KP96-7 ACOUSTIC UPGRADE KITS

90027633000 and 90027633001

Telex Communications, Inc. is constantly looking for ways to improve our products. This kit contains the parts necessary to upgrade an older keypad reflect the engineering changes made to the product. There are three upgrades.

**OLDER LEADED SSM 2015
MICROPHONE PREAMPLIFIERS**

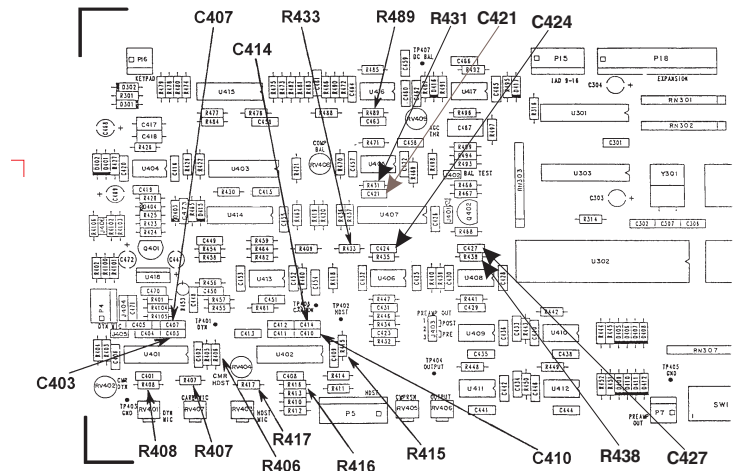
If your keypanel has the older leaded SSM 2015 Microphone Preamplifiers in U401 and U402:

- A) Remove C403, C410 and replace with zero Ohm resistors.
- B) Remove C402, C409 (Nothing is put back in these locations).
- C) Remove C407 and C414 and replace with 0.47 μ F capacitors (Frequency response upgrade).

- D) R408, R417, R406, and R415 are removed and nothing is installed in their place.
- E) R407 and R416 are removed and replaced with 10 Ohm, 5%, 1/4 Watt, resistors

- F) R433 is removed and replaced with 1.6K Ohm, 5%, 1/4 Watt, resistor.
- G) R489 is removed and replaced with 16K Ohm 5%, 1/4 Watt, resistor.
- H) Remove the 12 DIP sockets for U401 and U402.

- I) Solder new daughter board microphone preamplifier PCB assemblies in U401 and U402 locations.
- J) Change R431 and R438 to 39K Ohm resistor (5% will do)

- K) Change C421, C424 and C427 to Ceramic Caps 0.001 μ F
- L) Keypanel will need to have the levels readjusted after modification. See installation instructions, KP96 and KP97 manual 93307101001. Section 3 on electric adjustments has level readjustment procedure.

**NEWER DAUGHTER BOARD
MICROPHONE PREAMPLIFIERS**

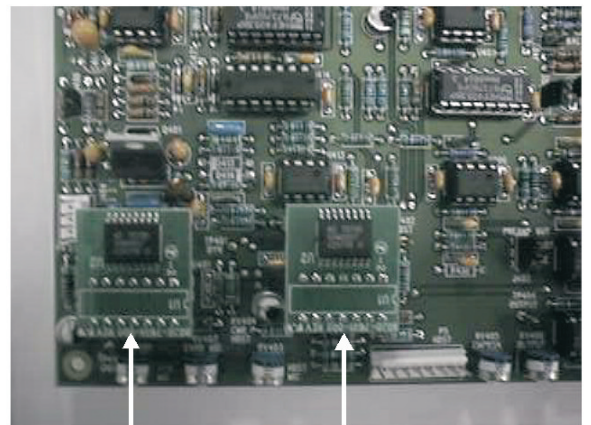
- M) If your keypanel already has the newer daughter board microphone preamplifier assemblies in U401 and U402 it is not necessary to replace them unless they are defective. Check C407 and C414 to confirm that they are 0.47 μ F, if not, replace them with the capacitor which came with your kit.

**OLDER THROUGH HOLE
CONSTRUCTION DKP-3 KEYPAD**

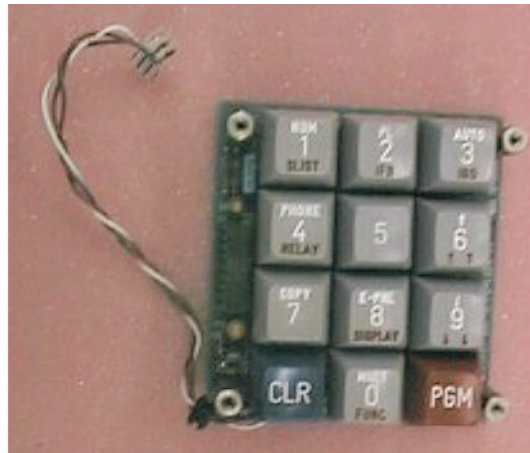
- N) If your keypanel has the older through hole construction DKP-3 you will need to add the 22 Φ F 50 Volt electrolytic capacitor in your kit to the P16 connector. The main PMB-95 circuit board will need to be removed because the leads of the capacitor are soldered on the bottom foil side.

The + led of this capacitor will connect to pin 3 and the negative lead will connect to pin 2 of P16.

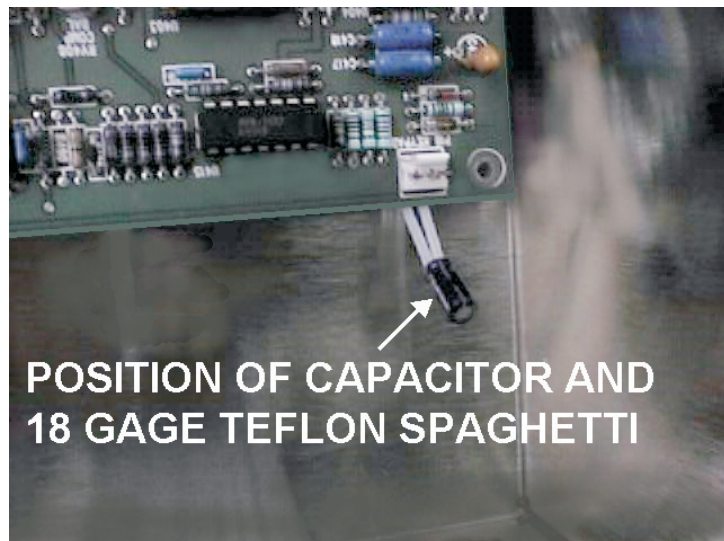
Use the two pieces of 18 gage Teflon spaghetti to on the leads of the capacitor and position the capacitor so it is in front of the PMB-95 circuit board.
